RE: **Freddy's**
131 Coors Blvd NW
Requested for 60 Day Temporary C. O. - Accepted
Engineers Stamp Date 7/7/15 (K10D001B)

Based on the certification provided in your submittal received 8/3/2016, the above referenced is approved for a 60-day Temporary Release of Occupancy by Hydrology. However, before a permanent CO can be accepted the following comments must be addressed.

FREDDY'S AT COORS AND CENTRAL	DRAWN BY DY
	GRADING AND DRAINAGE PLAN	DATE 7/07/15
	TERRA WEST, LLC 5571 MIDWAY PARK PLACE NE ALBUQUERQUE, NM 87109 (505) 858-3100 www.tierawestllc.com	2015036-GRE
		SHEET # C1
JOB # 2015036

POND OUTLET DETAIL
NTS

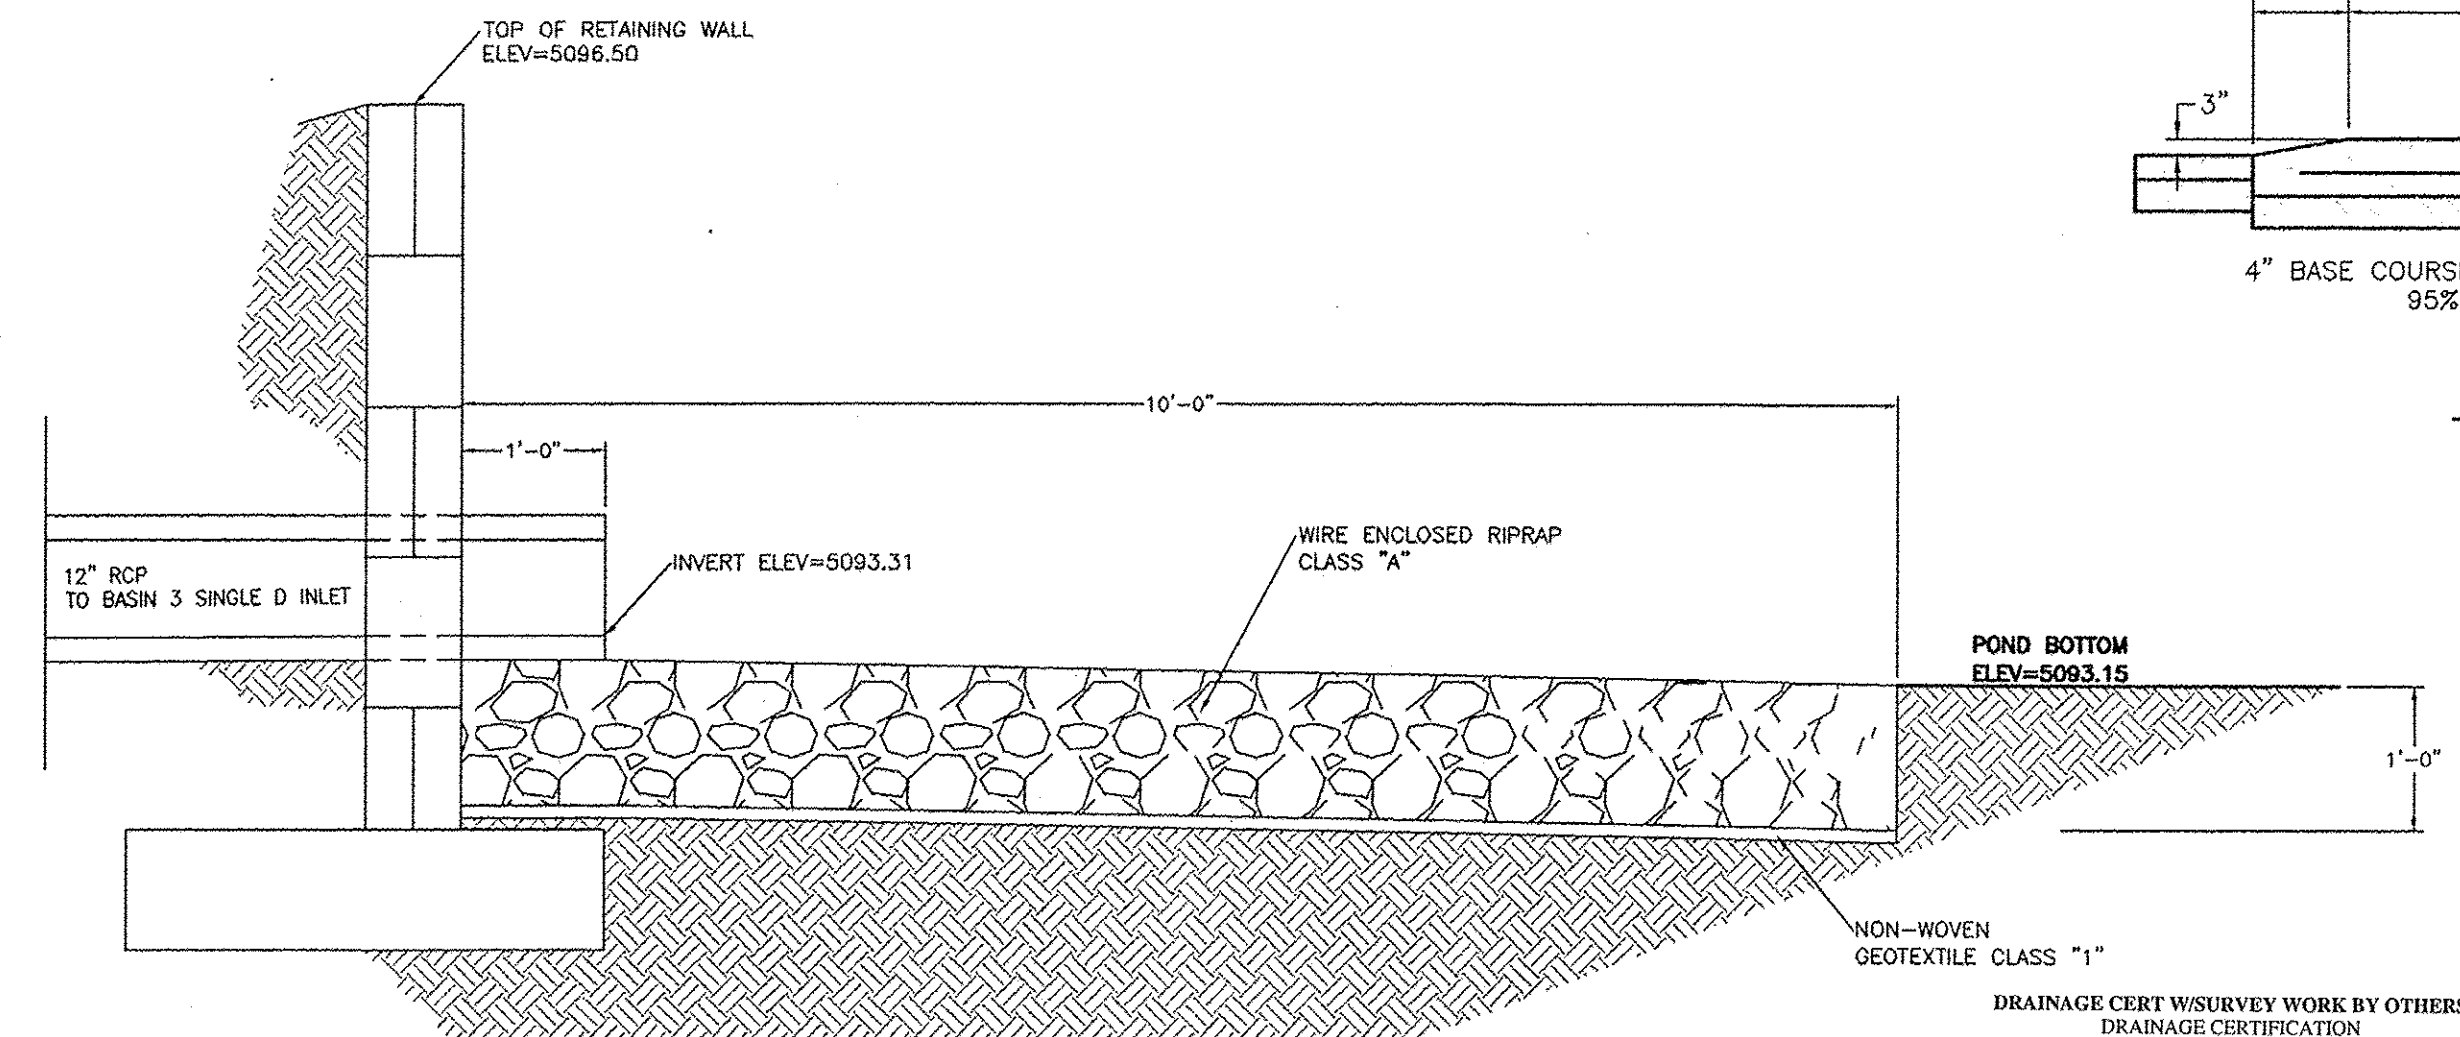
- The concrete spillway must be constructed
